**08/04/2016 Staff feedback on RAI 208-8245; Q 03.08.03-1**

In RAI 8245, Question 03.08.03-1 (parts (a) and (b)), the staff requested the applicant to describe a) how the pressure transient for a single sparger activation was developed; and b) what cases of activation (of the spargers) may occur. The staff reviewed the structural aspect of the response to part (a) and found it to be acceptable. However, NRC also needs to review the other aspect of the response that describes the methodology for computing the PORSV spargers pressure transient for acceptance.

Figure 1. The Scaling Factor with Different Initial Pool Temperature

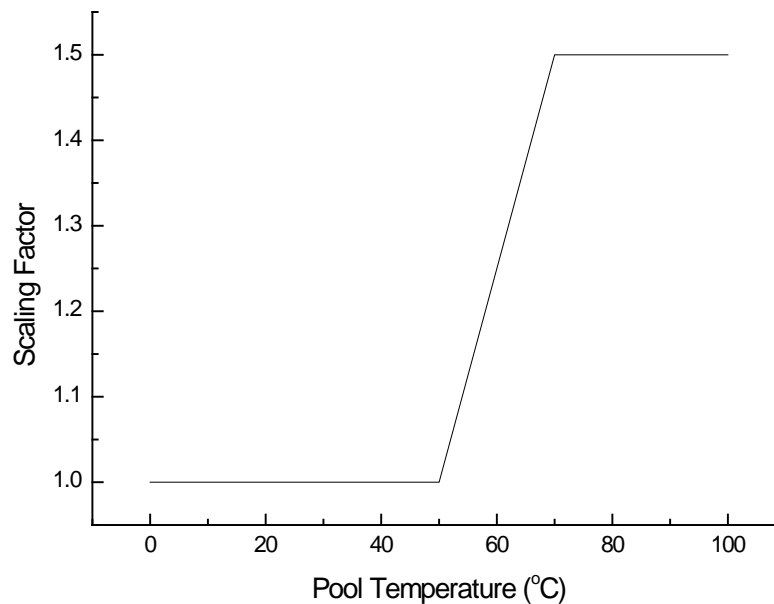
- 1) background for the scaling factors for part (a) (see below), specifically, n-sub-g, n-sub-z, and n-sub-v.
- 2) We also need to confirm that the equation on page 5/9 refers to  $r > 2r_0$  rather than just "0" (We have the background info that corroborates this, so this should just be a simple confirmation of a typo).

The Studsvik tests have indicated that the maximum pressure amplitudes are increasing noticeably with increasing pool water temperature above a level of about 50-60 °C. The scaling factor to account for differences in initial pool water temperatures is shown in the Figure 1. The maximum initial IRWST temperature is 120 °F (48.9 °C). Therefore, the scaling factor to account for differences in the pool water temperature,  $\eta_T$  is 1.0.
